Re: Shell Building @ Los Lomas
2101 Vista Oeste NW
Traffic Circulation Layout
Architect's Stamp **10-20-2017** (H10-D031)

Based upon the information provided in your submittal received 10-20-17, the above referenced plan cannot be approved for Building Permit until the following comments are addressed:

TITLE
Traffic Control Layout

Architectural Site Plan

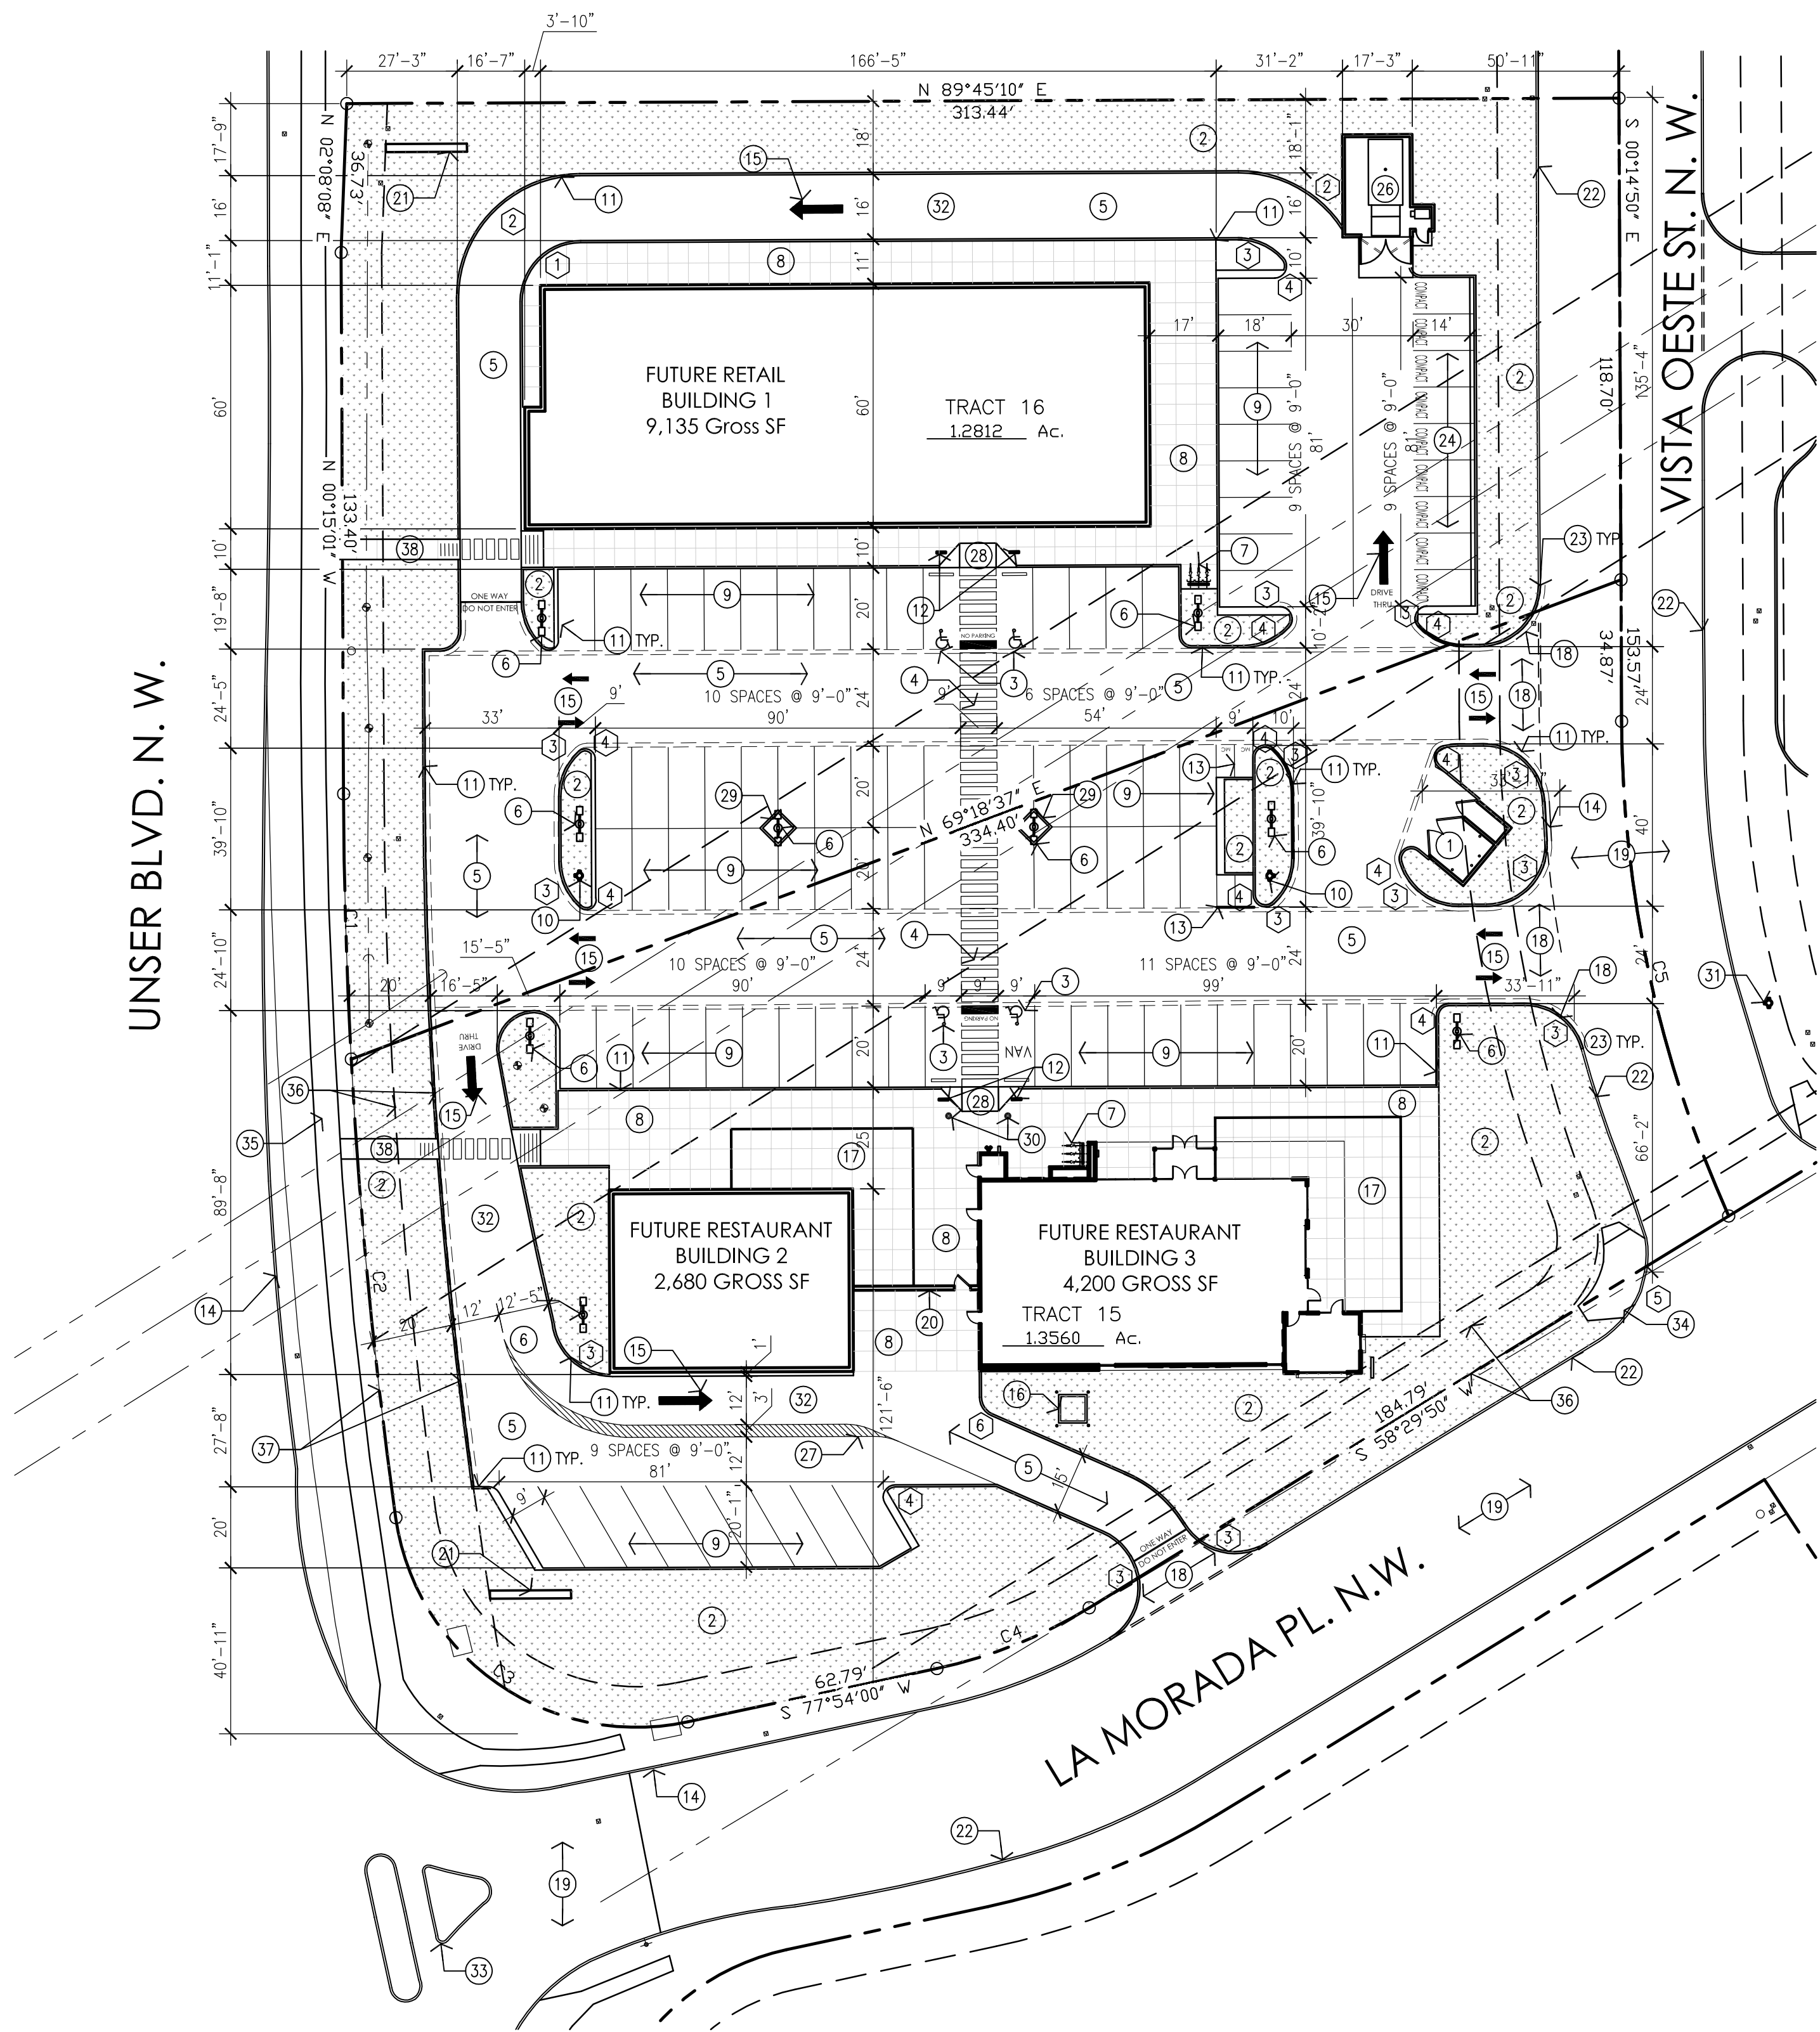
1. A scale of 1"=20' is recommended for sites less than 5 acres.
2. Please show a vicinity map showing the location of the development in relation to streets and well known landmarks.

3. Identify all existing access easements and rights of way width dimensions.
4. Identify the right of way width, medians, curb cuts, and street widths on adjacent streets.

5. List radii for all curves shown; for passenger vehicles, the minimum end island radius for passenger vehicles is 15 ft. Radius for delivery trucks, fire trucks, etc. is 25 ft. or larger.

6. ADA curb ramps fronting the site must be updated to current ADA standards and have truncated domes installed.
7. Per the zoning code, a 6 ft. wide ADA accessible pedestrian pathway is required from the public sidewalk to the building entrances. Please clearly show this pathway and provide details.

8. Sidewalk shall be required along the properties frontage. Sidewalk should be 4 feet wide along La Morada Pl and Vista Oeste. All sidewalks along streets should be placed at the property line.

9. One-way vehicular paths require pavement directional signage and a posted "**Do Not Enter**" sign at the point of egress. Please show detail and location of posted signs.

10. Show the clear sight triangle and add the following note to the plan:
"Landscaping and signage will not interfere with clear sight requirements. Therefore, signs, walls, trees, and shrubbery between 3 and 8 feet tall (as measured from the gutter pan) will not be acceptable in the clear sight triangle."
